SB-GA8-2012-77

Issue 4

Service Bulletin

Pitot Heat Connector at wing tip

Figure 1 – View of connector P50.

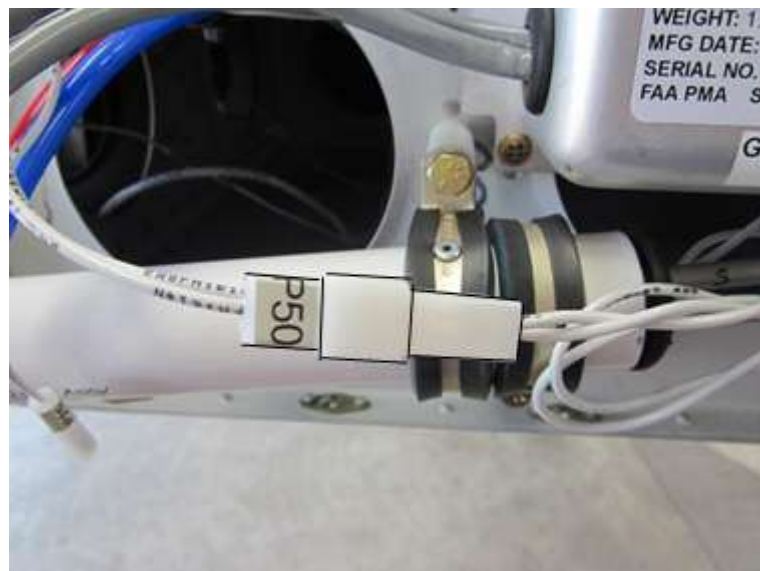
1. Remove the left hand wing tip from the aircraft. Wing tip removal instructions are provided in Section 57-30-00 of the Service Manual. **NOTE:** Take care as wiring to the Strobe/Nav light is still connected.
2. The electrical connection of P50 & J50 (Figure 1) must not be disconnected at this point in time. Look for signs of charring or discolouration of the connector housing. Inspect for signs of damage to the pitot or static lines in the near vicinity of the electrical connector.
3. In accordance with the directions stated in the Compliance statement of this Service Bulletin, Part 2 of this Service Bulletin is to be carried out. If carrying out Part 2 of this Service Bulletin immediately, proceed to Part 2, Step 2.

Figure 3 - Modified wiring to the pitot static tube assembly.

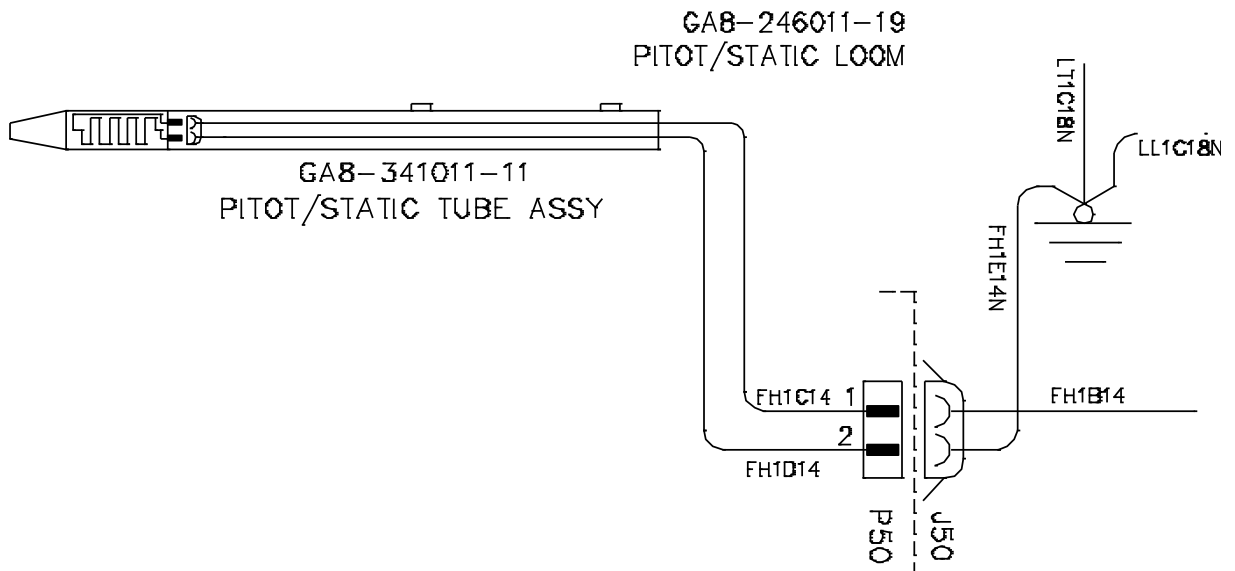
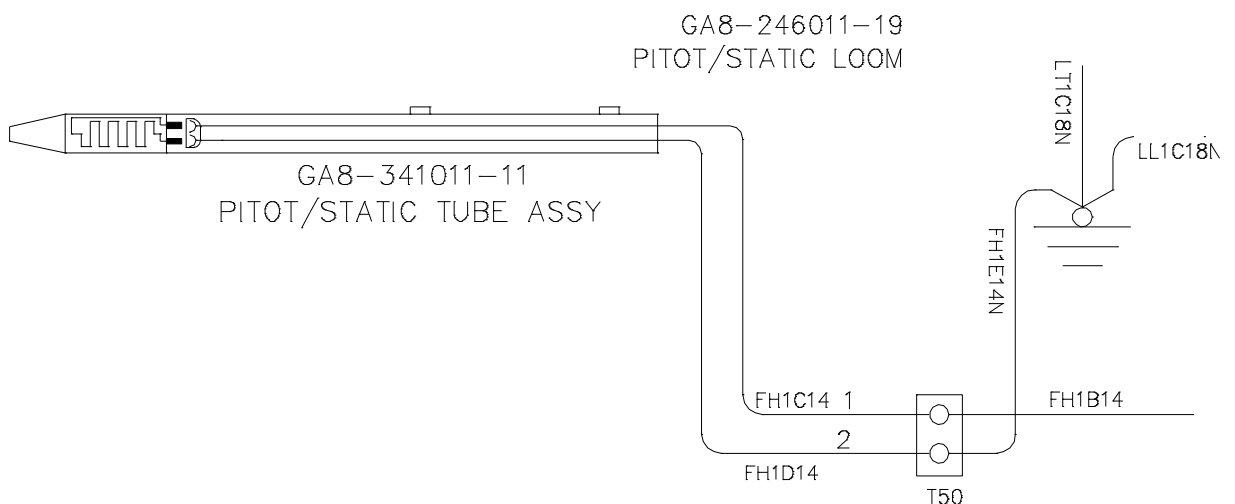
1. Remove the left hand wing tip from the aircraft. Wing tip removal instructions are provided in Section 57-30-00 of the Service Manual. **NOTE:** Take care as wiring to the Strobe/Nav light is still connected.
2. The standard aircraft wiring to the heated pitot is shown in Figure 2. The modified wiring is shown in Figure 3.

3. Discard connector housings P50 and J50, and cut-off the spade terminals.
4. Fit item 2. Alternatively item 14 may be modified in accordance with Figure 4. This can be done by using a hacksaw. File away any "plastic" burring.

Figure 6 - Ring terminals fitted.

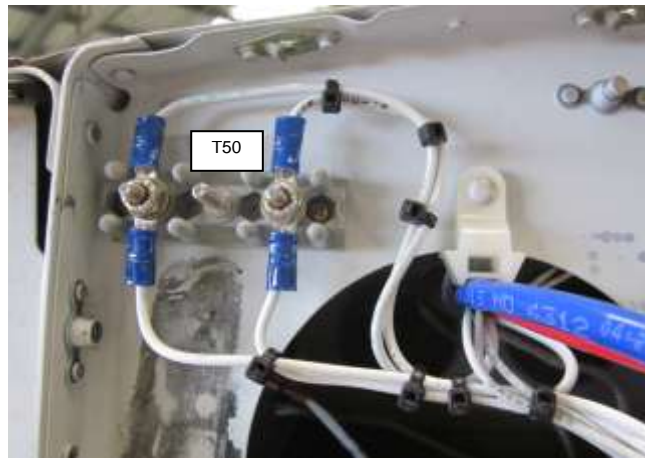
5. Crimp the ring terminals (item 8) to the wire leads.
6. Screw wire FH1C14 and wire FH1B14 to one stud.
7. Screw wire FH1D14 and wire FH1E14N to the second stud.
8. Placard "T50" to be fixed in near vicinity of the terminal strip.
9. Fit the terminal cover as shown in Figure 7. Use either item 1 or items 12 and 13 cut to length as shown in Figure 8.
